REQUEST FOR INFORMATION (RFI)

RFI No.: ABF-RFI-003204R00 **Submitted By:** OSullivan, Bill **Pages:** 2
Pages Attached: 1

Subject: Hinge AW, AE: Electrical	
References:	
Sub/Sup: BLI	**Sub RFI #:** RFI-BLI-000170R00
Response Required by: 28-February-2013	**Response affects critical path activity?** Yes

Project: 04-0120F4 - SAS

SK-RFI3204-E101A/186A

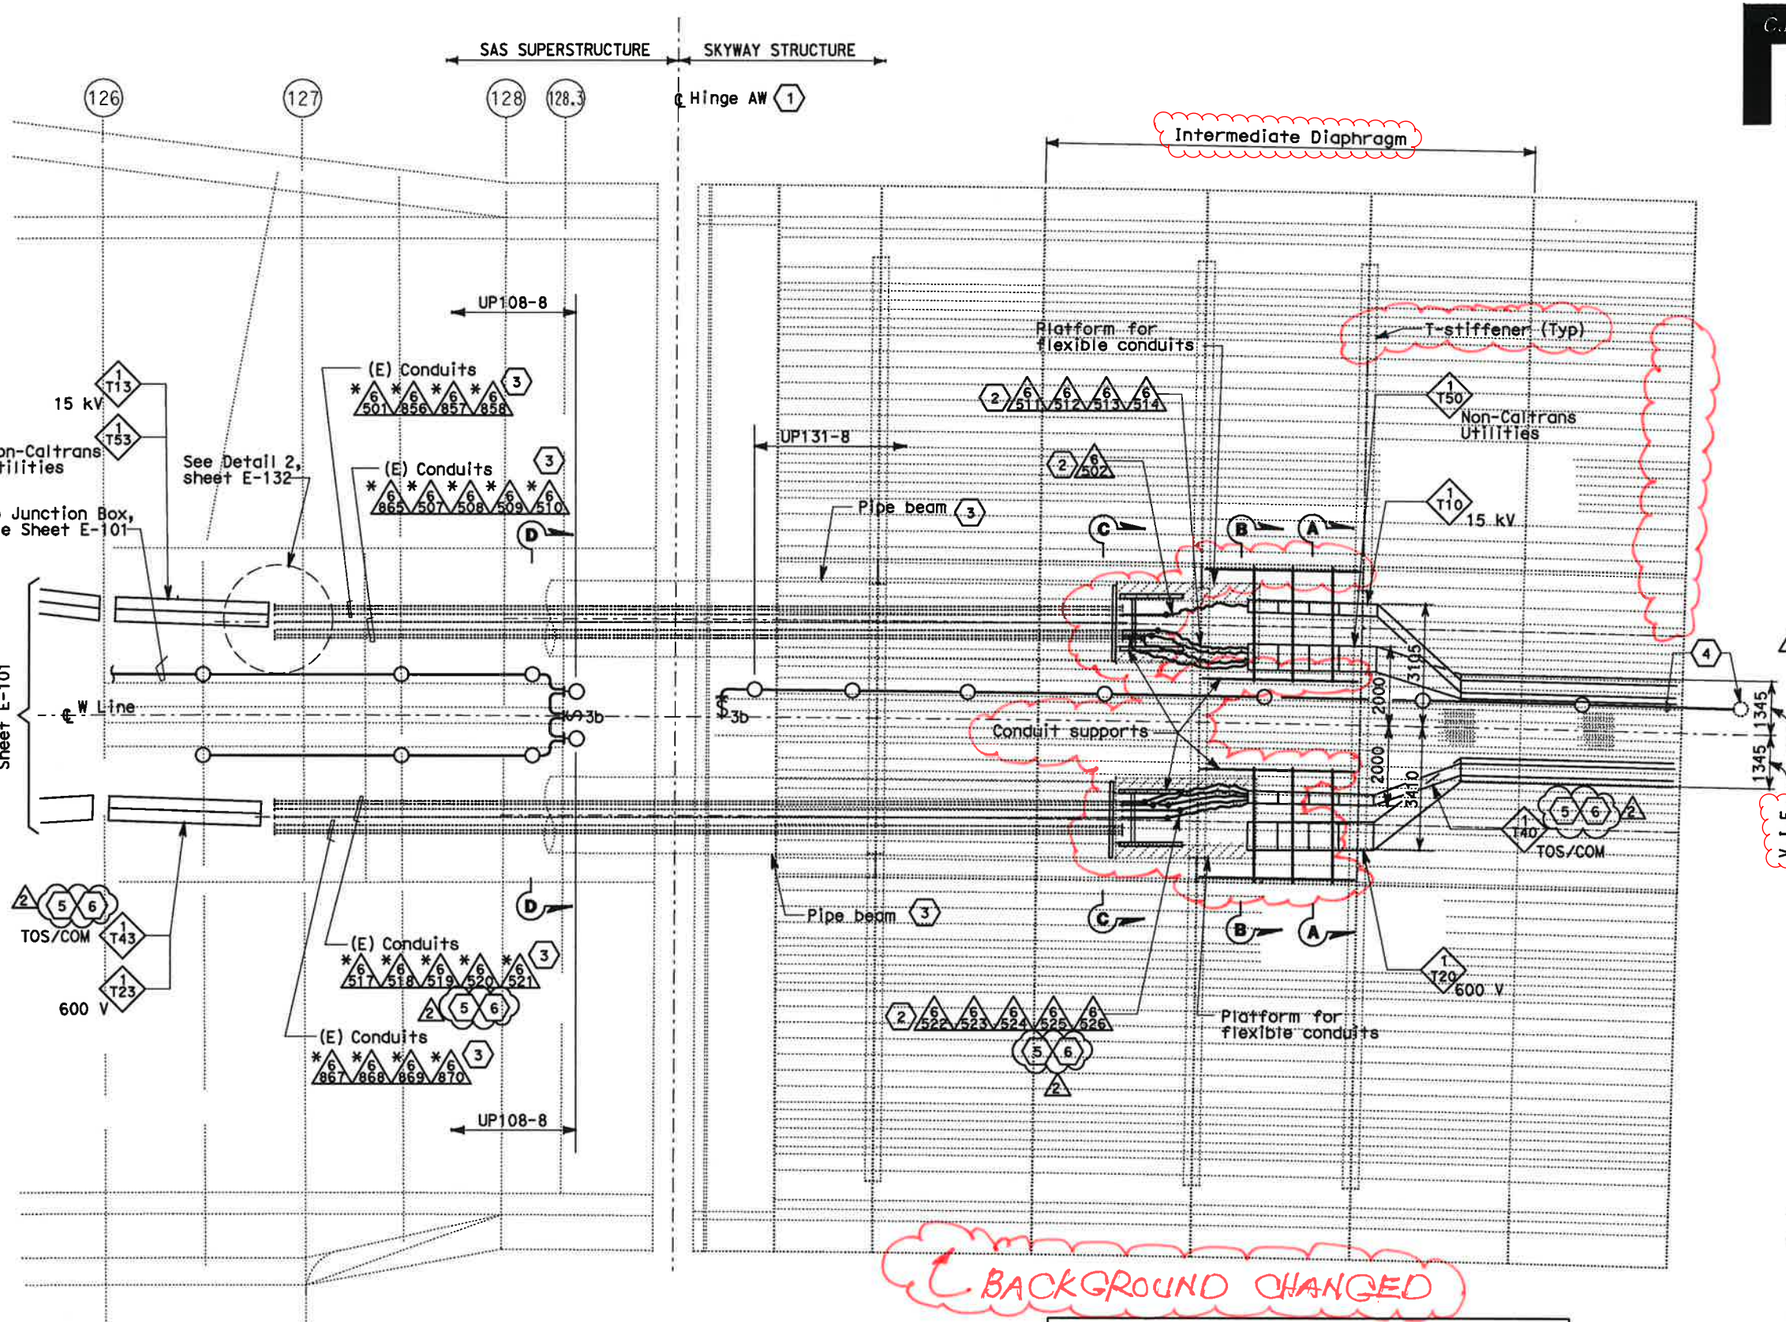
2. Ref. 186 and 242
a. Details 1, 2, 3. How is strut attached to the ceiling, wall and floor?
b. Section A-A and B-B. The connection to (E) cable trays in the Skyway are a top/bottom configuration, passing through an opening in the steel structure. The 15kV and non-Caltrans trays are routed side by side. Is the 15kV tray routed underneath the non-Caltrans tray with adjustable angles not shown? Where and how is this done in the limited space available?

2b. The 15kV and non-Caltrans utilities trays and similarly 600V and TOS/COM cable trays shall be routed as shown in attached sketches SK-RFI3204-E101A/186A and SK-RFI3204-E132A/221A. The adjacent cable trays are routed side by side as they exit the loop and transitions into top-bottom configuration to meet the existing cable trays at the Skyway OBG diaphragm opening. Similar cable tray layout has been used at Hinges B, C and D inside the Skyway structure.

SK-RFI3204-E132A/221A

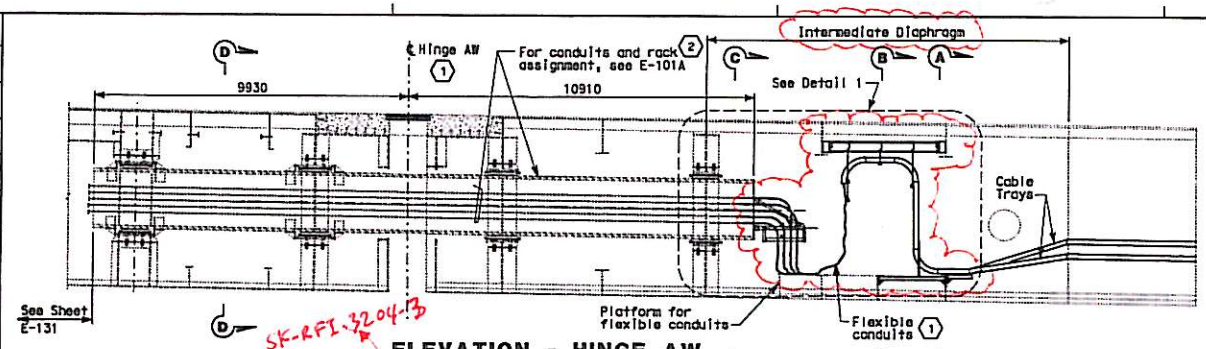
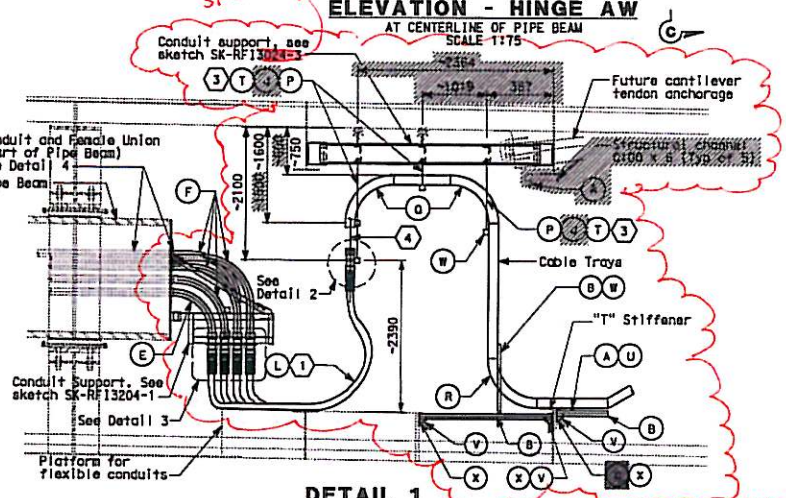
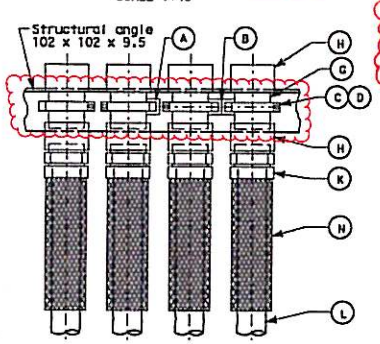
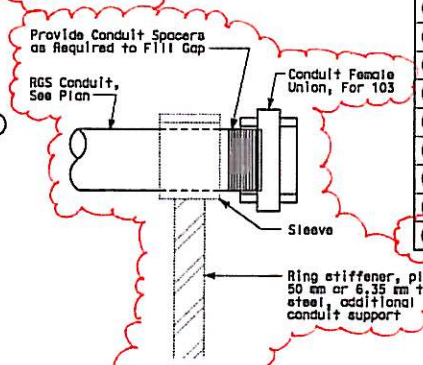
1. Ref. 185 and 241
a. Sheet Note 4. Propose Amtec conduit riser grip in lieu of strain relief grip attached from vertical cable tray rungs.
b. Material List Item J. Furnish make and model of swivel ceiling flange.
c. Conduit Support Detail 3. Is structural angle 102x102x9.5 for strut straps only? Is the remainder of the conduit support fabricated from strut channel? How is the conduit support attached to the pipe beam? Note that a shop-welded support will not fit through the structure, plan is to fabricate the support in the field with bolted strut.
d. Detail 1 Structural Channel C100x8. How is the channel attached to the ceiling? Where is the quantity of 5 located?

a) Sheet Note 4 specifies that all cables entering the liquidtight conduits from the cable trays shall be provided with strain relief cable grips attached from the vertical cable tray rungs. Contractor is proposing to use Amtec conduit riser grip in lieu of strain relief grip attached from vertical cable tray rungs.

b) Item J of the material list specifies “Swivel ceiling flange” for attachment of cable tray hangers to the ceiling. Contractor is requesting make and model of the listed “Swivel ceiling flange”.

Contract plan sheets 185 and 241:
1a. The Department takes no exception to the Contractor's proposal to use Amtec conduit riser grip attached from the vertical cable tray (size as required) in lieu of the strain relief grip to support the vertically routed cable. Note 4 on sketch SK-RFI3204-E132A/221A has been updated to reflect this change.

1b. Attachment details for cable tray hangers have been revised and "Swivel ceiling flange" is no longer required. Attached sketches SK-RFI3204-E132A/221A, SK-RFI3204-03 thru SK-RFI3204-05 shows the revised configuration for attachment of cable tray hangers.

a) Contractor's proposal to use Amtec conduit riser grip attached from the vertical cable tray (size as required) in lieu of the strain relief grip to support the vertically routed cable is acceptable. See attached sketch SK-RFI3204-E132A/221A.

b) Attachment details for cable tray hangers have been revised. "Swivel ceiling flange" is not required. Attached sketches SK-RFI3204-E132A/221A, SK-RFI3204-03 thru SK-RFI3204-05 shows the revised configuration for attachment of cable tray hangers.

SK-RFI3204-E132B/221B

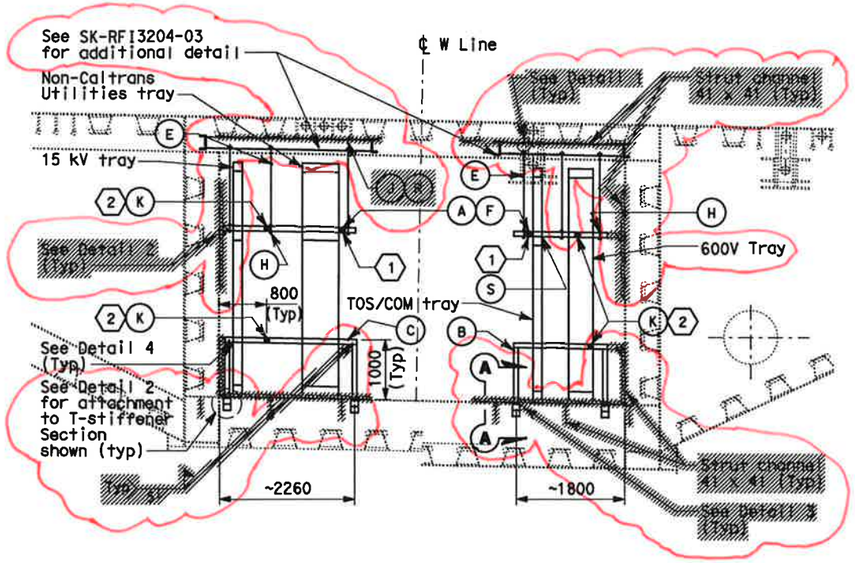
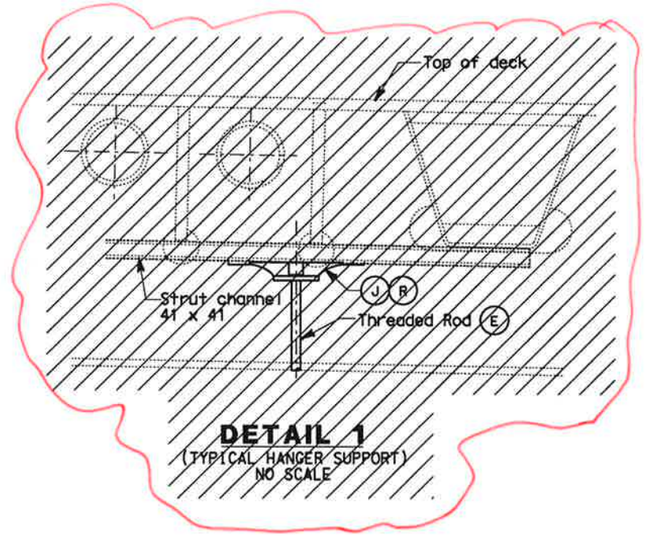
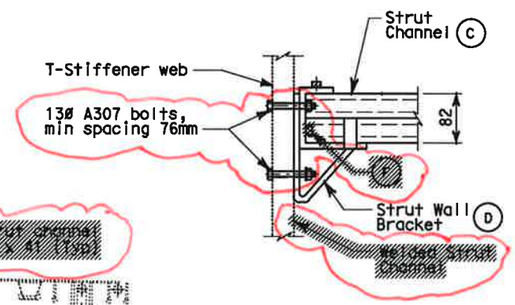
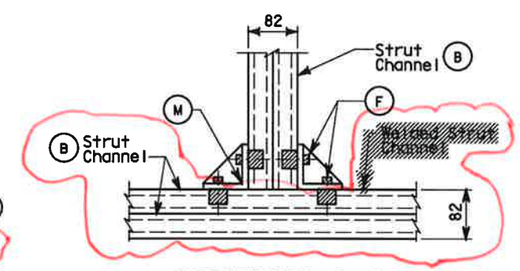
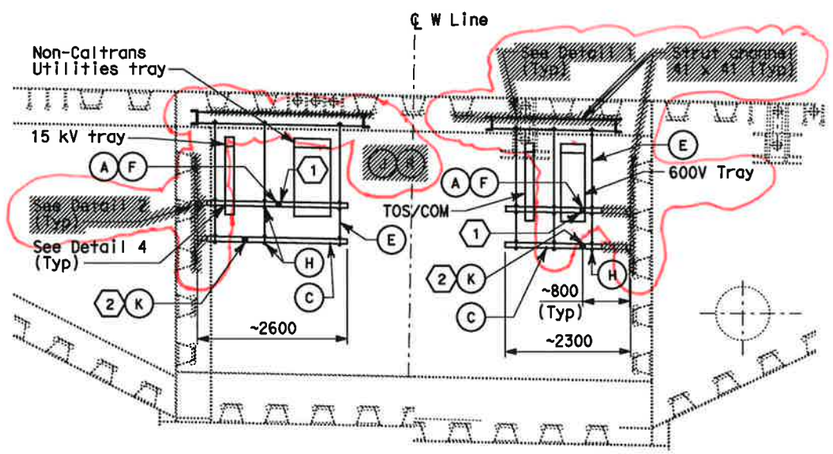
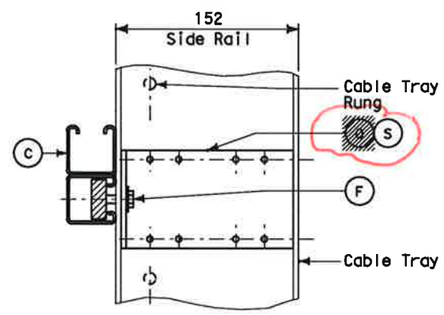
a) Details 1, 2, 3 shows strut channels attached to the OBG structure. Contractor is requesting information for attachment of strut channels to the ceiling, wall and floor of the OBG.
   b) Contractor states that the connection to (E) cable trays in the Skyway are a top/bottom configuration, passing through an opening in the OBG structure. Sections A-A and B-B on the contract plan sheets shows the 15kV and non-Caltrans trays routed side by side. Contractor is requesting clarification whether the 15kV tray routed underneath the non-Caltrans tray with adjustable angles not shown in the section view and how this can be done in the limited space available inside the OBG.

Contract plan sheets 186 and 242:
2a.The struts shown on the contract plan sheet were intended to be welded to the OBG structure under Skyway contract. However, these struts were not installed in that contract. Please provide attachment of cable tray supports to the OBG structure per the attached sketch SK-RFI3204-E132B/221B.

a) The struts shown on the contract plan sheet were intended to be welded to the OBG structure in a separate contract. However, these struts were not installed in that contract. Attached sketch SK-RFI3204-E132B/221B provides revised details for attachment of cable tray supports to the OBG structure.
   b) The 15kV and non-Caltrans utilities trays and similarly 600V and TOS/COM cable trays shall be routed as shown in attached sketches SK-RFI3204-E101A/186A and SK-RFI3204-E132A/221A. The adjacent cable trays are routed side by side as they exit the loop and transitions into top-bottom configuration to meet the existing cable trays at the Skyway OBG diaphragm opening. Similar cable tray layout has been used at Hinges B, C and D inside the Skyway structure.

SK-RFI3204-01

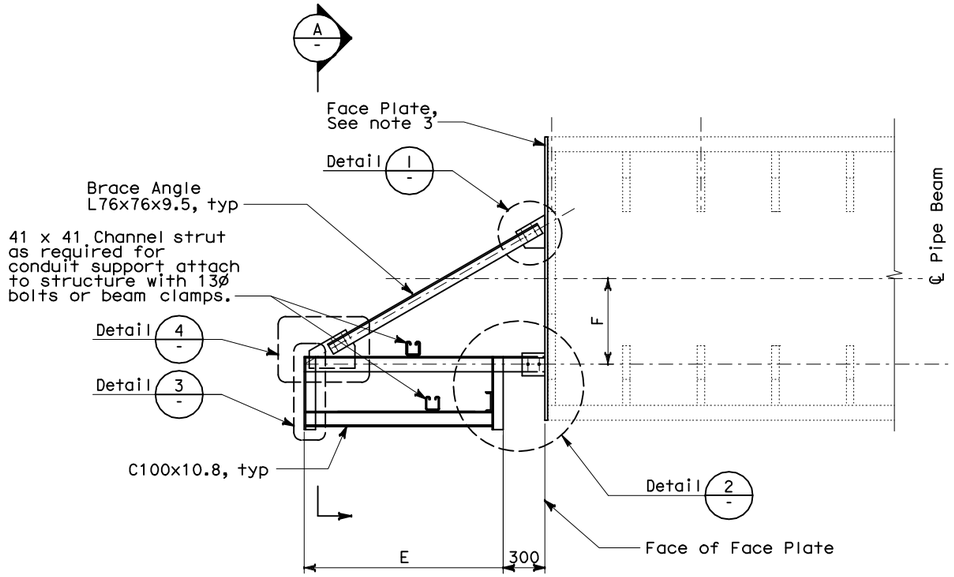
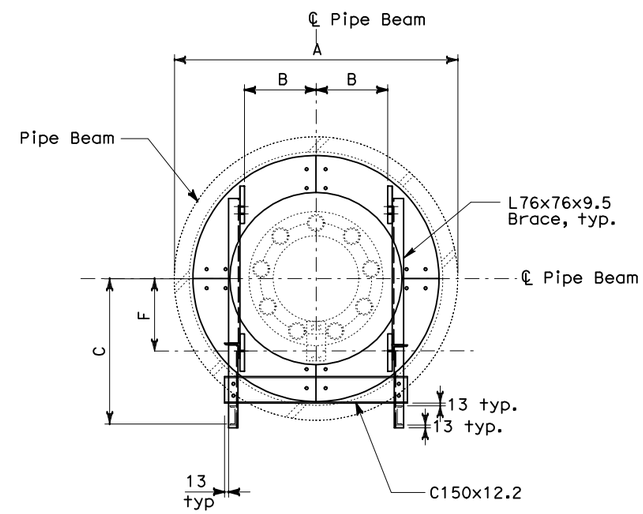
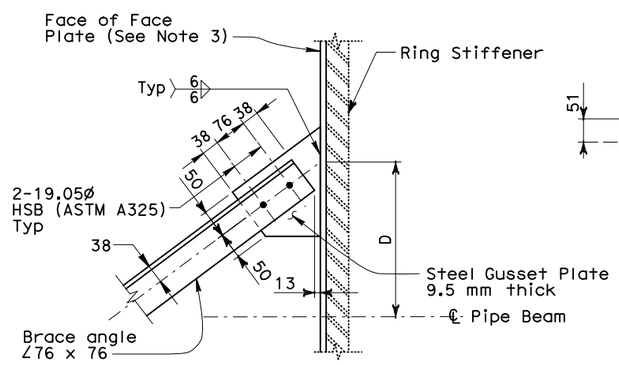
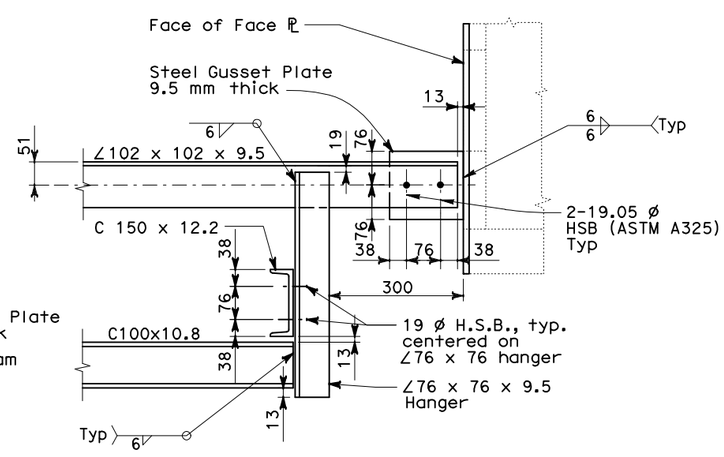
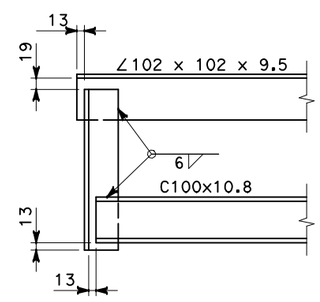
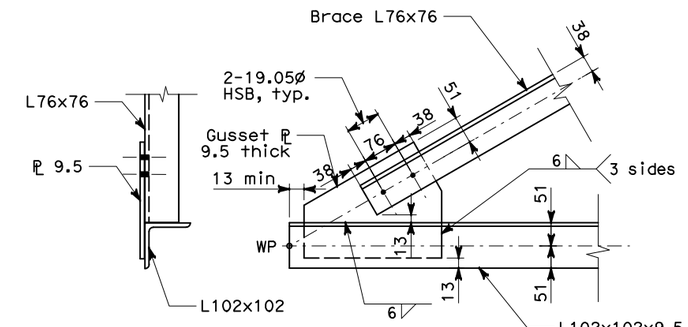
c) Conduit support detail 3 shows structural angle 102x102x9.5. Contractor is requesting information whether this angle is for strut straps only. Contractor is also requesting further details for conduit support and its attachment to Hinge Pipe Beam. Contractor notes that a shop-welded conduit support will not fit through the OBG structure access way and intend to fabricate the support in the field with bolted strut.

1c. Conduit support and its attachment to Hinge A Pipe Beam has been revised. Please find attached

sketches SK-RFI3204-01 thru SK-RFI3204-02 for details.

c) Contractor's proposal to use bolted strut conduit support at Hinge Pipe Beam is NOT acceptable. Attached sketches SK-RFI3204-01 thru SK-RFI3204-02 provides details for conduit support and its attachment to Hinge Pipe Beam at Hinge A.

SK-RFI3204-03

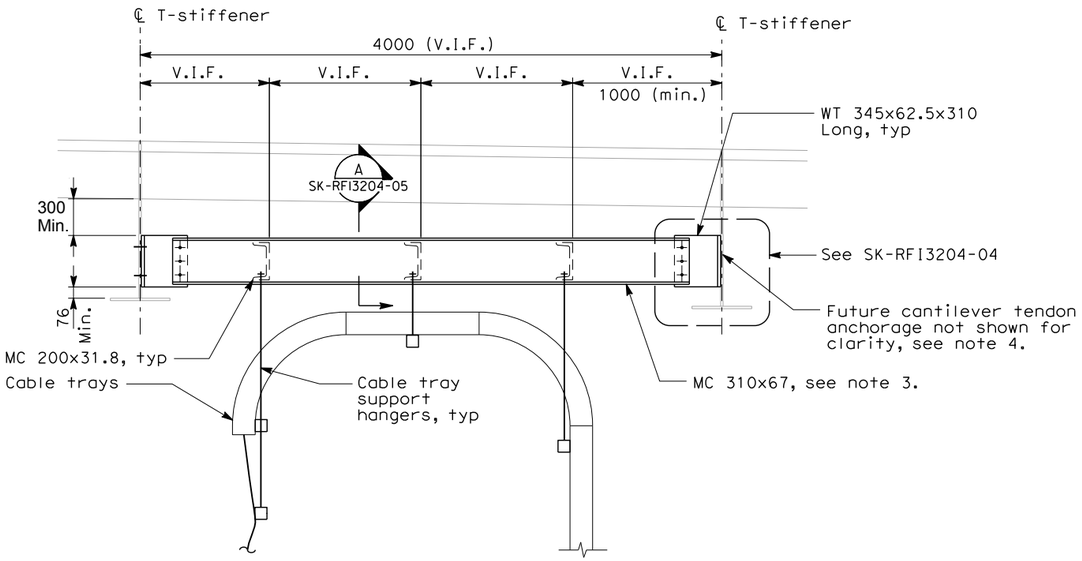
d) Detail 1 shows structural channel C100x8. Contractor is requesting information for attachment of the channel to the OBG ceiling. Contractor is requesting clarification for the quantity of channels indicated as five (5) on the contract plan sheet.

1d. Conduit and cable tray support at Hinge A and attachment of cable tray hanger supports to the OBG structure has been revised. Please find attached sketches SK-RFI3204-E132A/221A, SK-RFI3204-03 thru SK-RFI3204-05 for details.

d) Attached sketches SK-RFI3204-E132A/221A, SK-RFI3204-03 thru SK-RFI3204-05 provides revised details for conduit and cable tray support at Hinge A and attachment of cable tray hanger supports to the OBG structure.
